# Verified Carbon Standard

## VALIDATION-VERIFICATION REPORT

### JURUÁ REDD+ PROJECT

<b>Project Title</b>	Jurua REDD+ Project
<b>Report Title</b>	Validation and Verification report of Jurua REDD+ Project
<b>Version</b>	04
<b>Report ID</b>	VCS.VAL.22.155
<b>Verification Period</b>	from 31/July/2020 to 30/July/2022
<b>Client</b>	Bioflica Ambipar Environmental Investment S/A and Amazônia Agroindústria EIRELI
<b>Pages</b>	231
<b>Date of Issue</b>	30-June-2025
<b>Prepared By</b>	Earthood Services Limited
<b>Contact</b>	<i>Address: 1203-1205, 12th Floor, Tower B, Emaar Digital Greens, Sector 61, Gurugram, Haryana, India 122102</i> <i>Phone: +91 1244204599</i>

Figure 4: Sum of the area calculations in ArcGIS and QGIS (Figure A, sum of the values calculated in ArcGIS and Figure B, sum of the values calculated in QGIS)

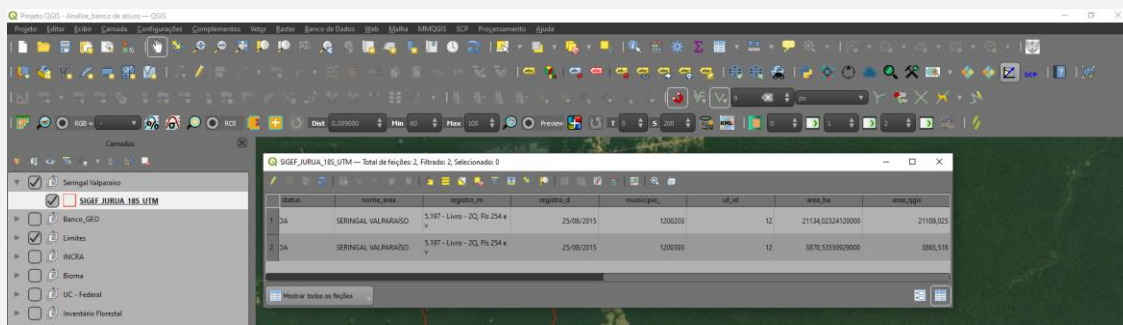
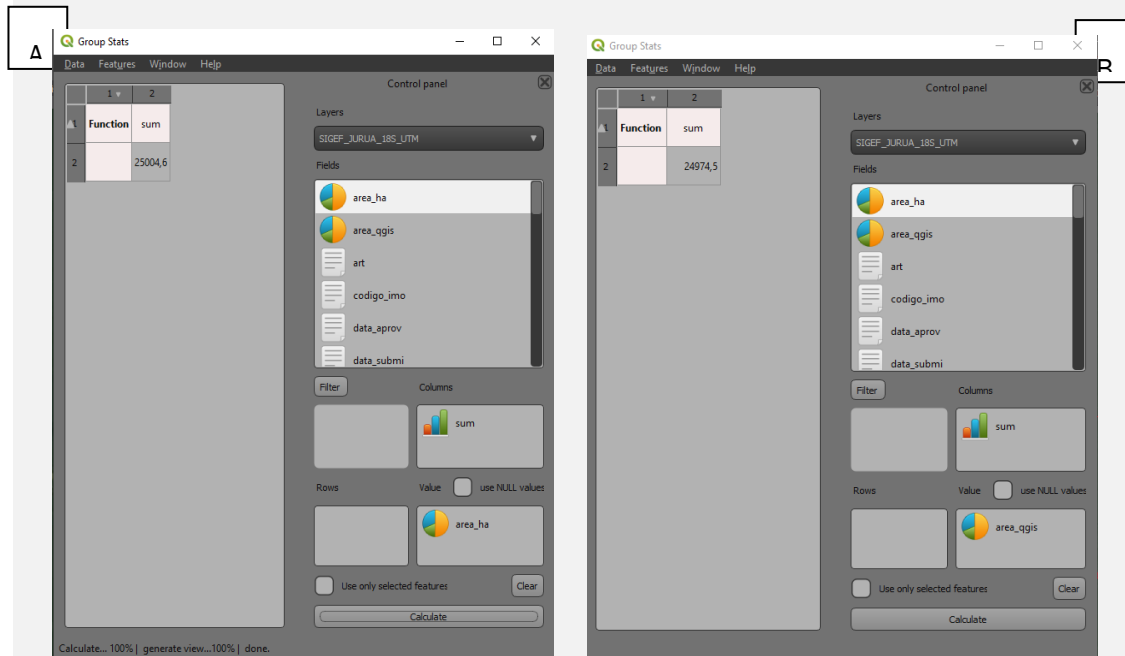
The project proponents clarified that the variation of the values between property documents, however in figure 4 presented above it is said “Sum of the area calculations in ArcGIS and QGIS (Figure A, sum of the values calculated in ArcGIS and Figure B, sum of the values calculated in QGIS)”; but both of the figures are taken from QGIS software as its icon shows. Besides, the value presented in section 1.7 of the updated joint PD/MR does not correspond to none of the values indicated in figure 4 of the project proponents response.

The value of the area calculated by ArcGIS is equivalent to 25004,06 ha and the value of the area calculated by QGIS is equivalent to 24974,5 ha as shown in the Figure 4.

Figure 10 in the PD/MR\_v5 was updated and contains FAP-Alluvial in the legend (1, 4 and 5).

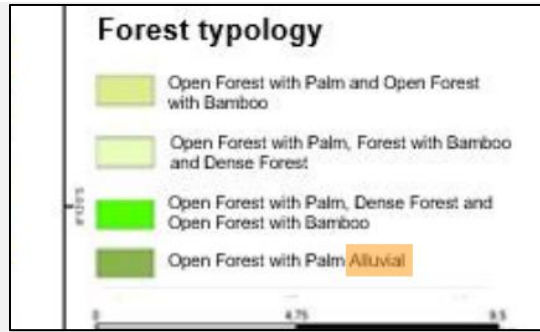
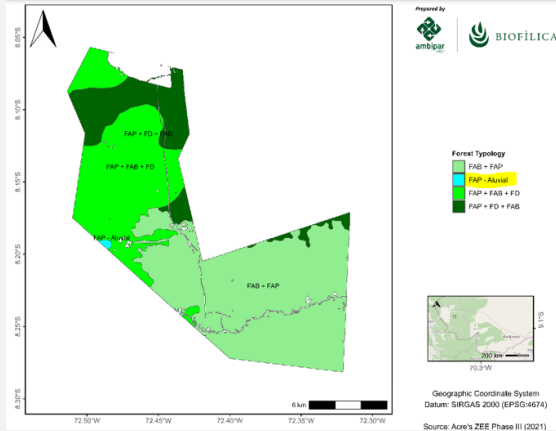
- Considering the description of the forest typologies, Figure 10 shows the map of the forest typologies of Seringal Valparaíso, but the typologies described do not coincide with those indicated in Table 6 (the 'Open forest with Palm Alluvial' was not described in the table) and therefore it is not clear which areas are the forest typologies in the project area.
